David Kelly's report was as follows:

IMMERSION 1

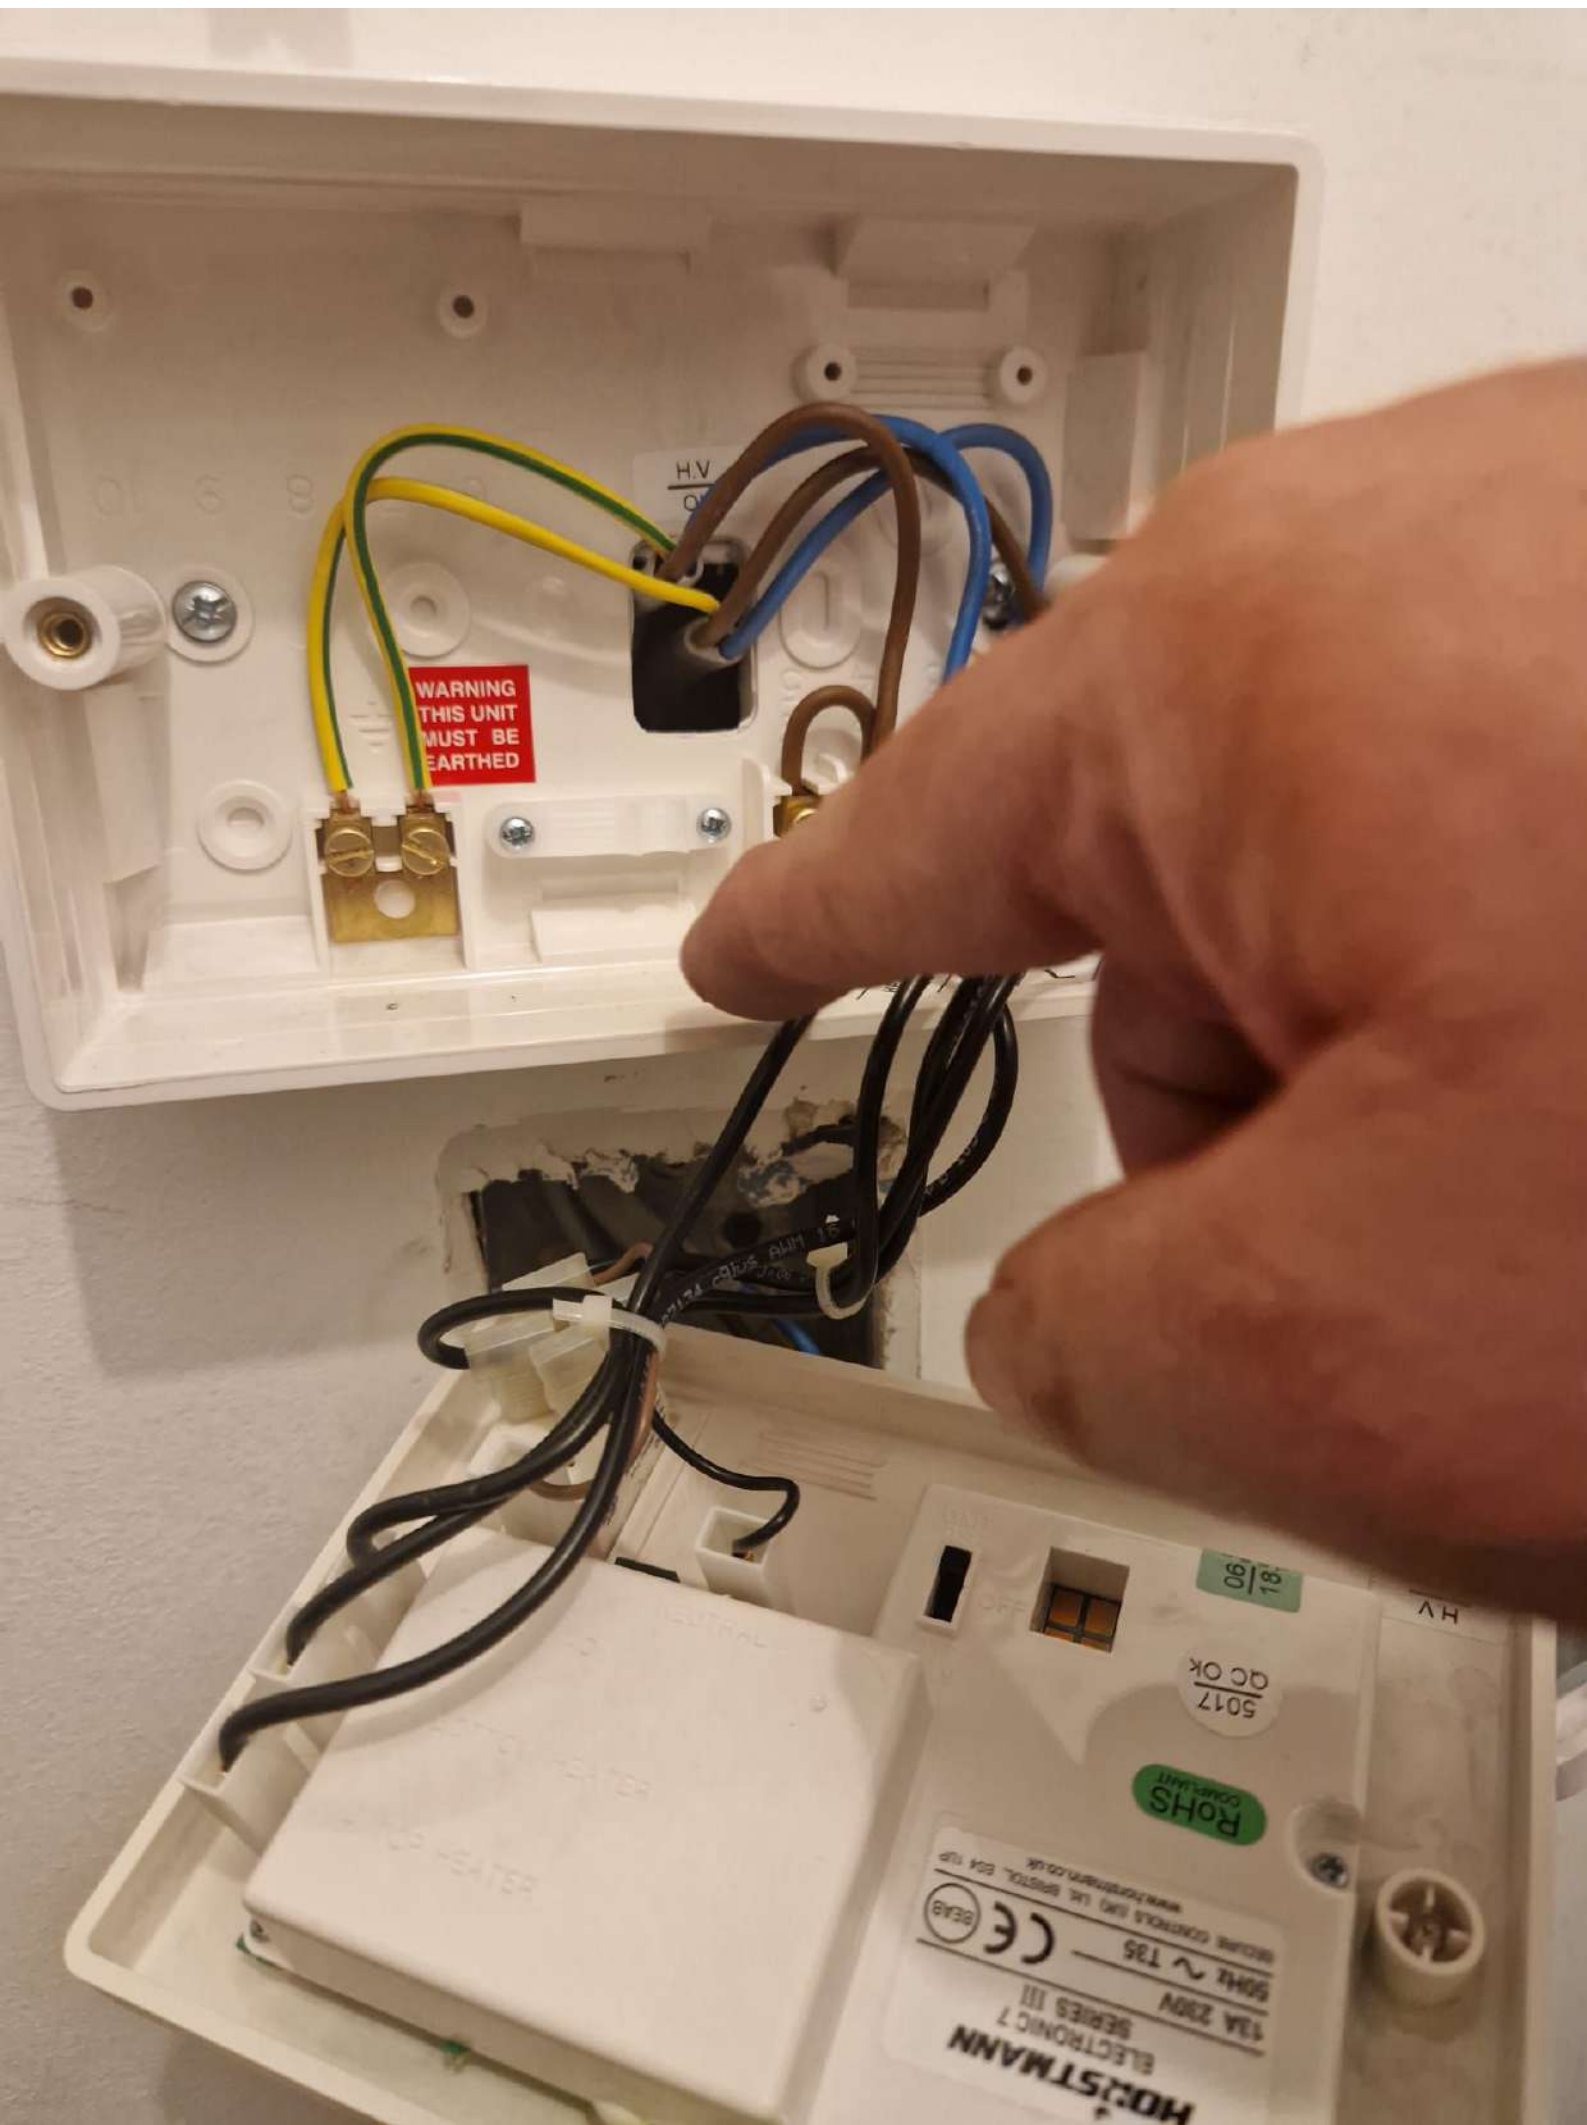
The Horstmann control unit was wired incorrectly since fitting. The unit had two supplies when only fit for one. The Immersion 1 off peak (base heating unit) was connected via a link to the Immersion 2 peak heating unit as shown in the image. This has likely caused a continued overload of Immersion 1.

The electronic display and control unit is designed to run off the supply of one switch with an insitu boost switch to operate the second immersion heater if needed to boost hot water supply. This was not how the product in Apartment 8 was wired.

Wiring corrected and switch tested to 20amp fuse tolerance.
